SERVICE BULLETIN

Classification: BT98-031	Reference: NTB98-100	Date: December 1, 1998
-----------------------------	-------------------------	---------------------------

1998 MAXIMA LEFT REAR DOOR DOESN'T UNLOCK WITH REMOTE

APPLIED VEHICLE: 1998 Maxima (A32)
APPLIED DATE: Vehicles built before May 6, 1998

Figure 1

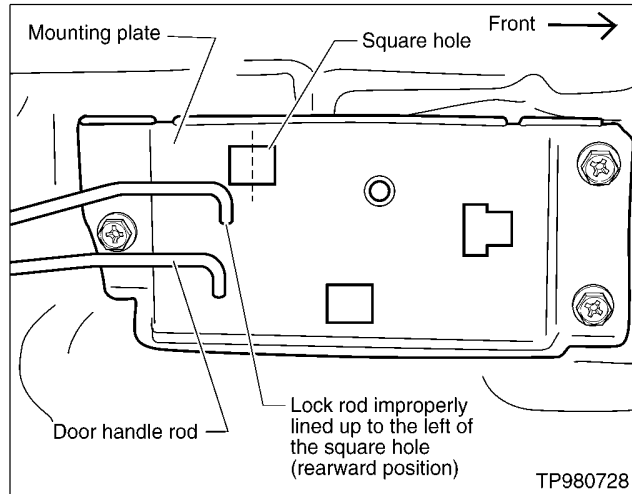
5. Move the lock rod to the rearward position.
6. Look at the position of the lock rod in relation to the square hole in the door handle mounting plate. An improperly positioned lock rod will be too short and will line up to the left of center of the square hole when the lock rod is moved into the rearward position (see Figure 1).

Figure 2

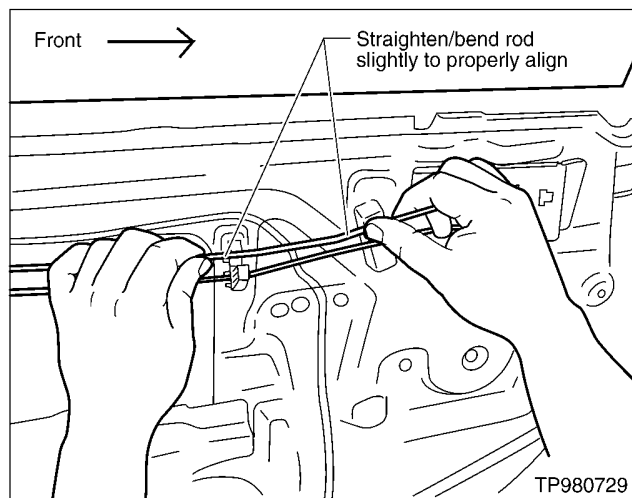
7. If the lock rod is too short and does not line up with the center of the square hole, slightly lengthen the rod by straightening/bending it (see Figure 2) until it is properly lined up with the center of the square hole in the door handle mounting plate (see Figure 3).
